Groundwater Transfer Review Summary Form

Transfer/PA # T- 13556

Application: T-13556

Applicant Name: Will E. McGill Living Trust

This drawdown analysis: authorized POA (MARI 16030) to nearest groundwater right (MARI 16006, ~1,700 ft)

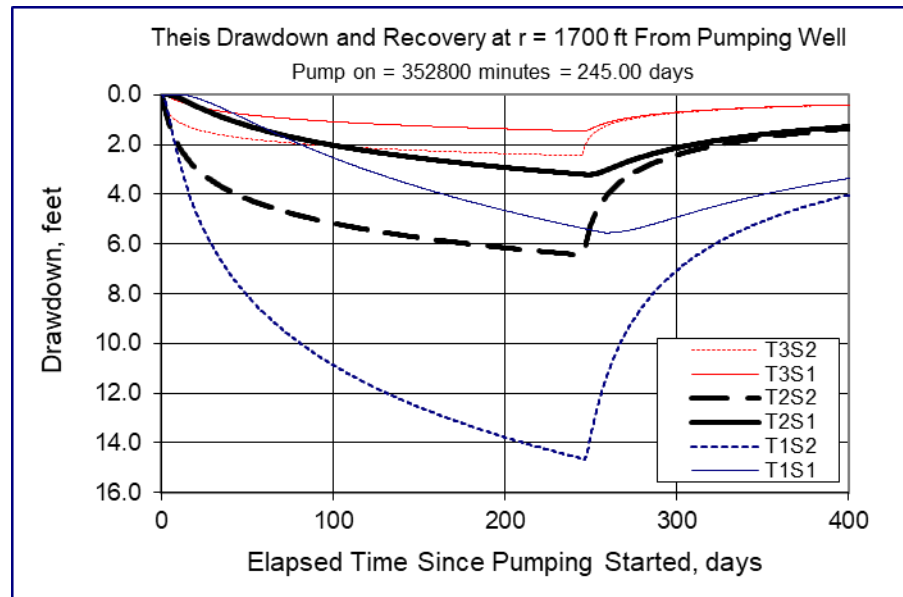
☒ Yes ☐ No Comments: Compared to the location of authorized POA MARI 16030 ("Well No. 2"), the location of the proposed APOA MARI 16029 ("Well No. 1") is approximately 750 feet nearer to another groundwater right (Claim GR-411, MARI 16006). Given the maximum authorized rate of use ($Q_{\max} = 0.7798 \text{ cfs} + 1.114 \text{ cfs} = 1.8938 \text{ cfs}$, 850 gpm), this proposed use will likely result in increased interference at the authorized POA for Claim GR-411 (MARI 16006). Interference with MARI 16006 is estimated to be between 2–20 feet, assuming the hydraulic conductivity of the shallow alluvial aquifer is in the range of 50–500 ft/day (Woodward et al. 1998 and Conlon et al. 2005).

☐ Yes ☒ No If yes, explain: While GR-1055 has a more junior priority date (5/1/1947) compared to Claim GR-411 (12/31/1939), the authorized POA for Claim GR-411 (MARI 16006) does not fully penetrate the shallow alluvial aquifer. If MARI 16006 fully penetrated the shallow alluvial aquifer, the proposed change would be unlikely to deprive MARI 16006 of the water to which it is legally entitled under Claim GR-411.
